INDEPENDENT REVIEW

LANDSCAPE & VISUAL IMPACT

Land East of Warwick Road, Banbury

This Independent Review of Outline Planning Application 23/00853/OUT Land East of Warwick Road, Banbury has been prepared on behalf of Cherwell District Council by Mark Cooper.

Photoviewpoint EDP 10: PRow 239/3/10

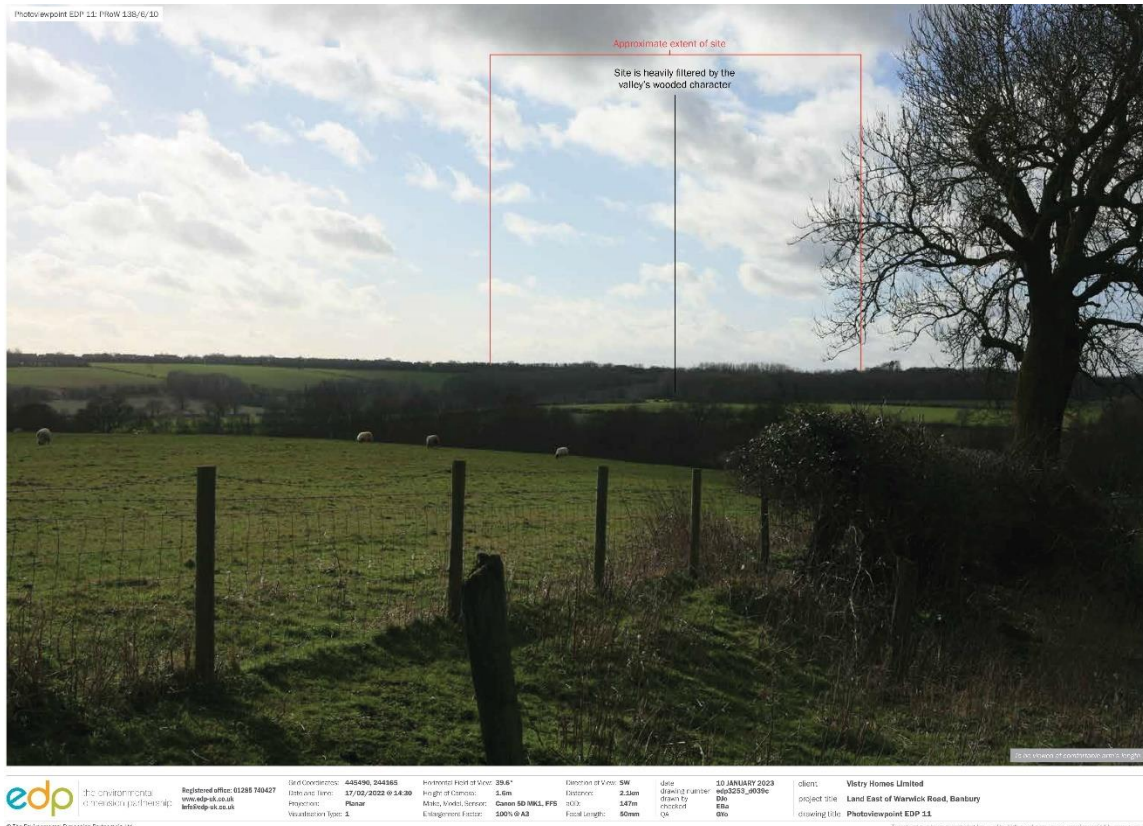
Above – This image is taken from PRow 138/6/10 on the north side of Hanwell looking south towards the site 745m away. It is possible that, in Winter, views of the roof-line of proposed houses on Parcel A would be visible through the tree belt on Main Street, Hanwell and through the more distant hedgerow with trees along the northern site boundary.

Users of PRow 239/4/10, 239/5/10 and 239/3/10 North of Hanwell

ES LVA Chapter 7 Clauses 7.180-7.185 describes the sensitivity of users of PRow 239/4/10, 239/5/10 and 239/3/10 as **'High'**, the magnitude of change **'Low'** and the indirect, permanent, medium-term adverse effect will be **'Minor to Moderate'** reducing to **'Minor'** in 15 years with a **'Not Significant'** residual effect.

Photoviewpoint EDP 11: PRoW Little Bourton

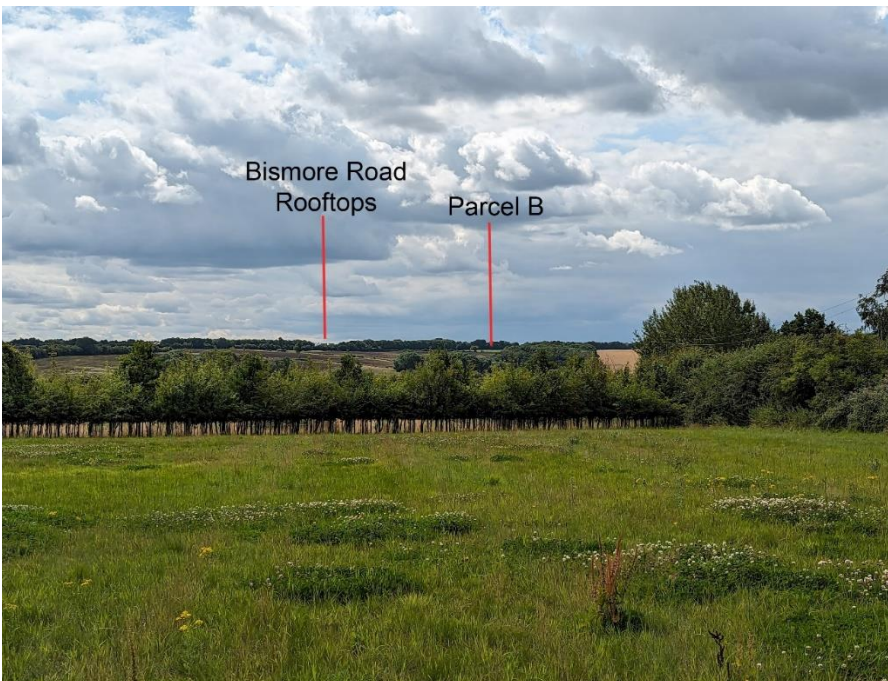
Above – This image taken from close to Little Bourton 2km north-east of the site shows that the site location is not currently definable by eye and that the proposed houses on Parcel A would not be visible even during the winter months.

Above – A smartphone image taken in July 2023 at 2km distance, from the public road north-east of Hanwell, south-west of Great Bourton, shows that the woodland around Hanwell village and the topography of the ridge-line obscure views of either Parcel A or B and would similarly hide buildings on Parcel A.
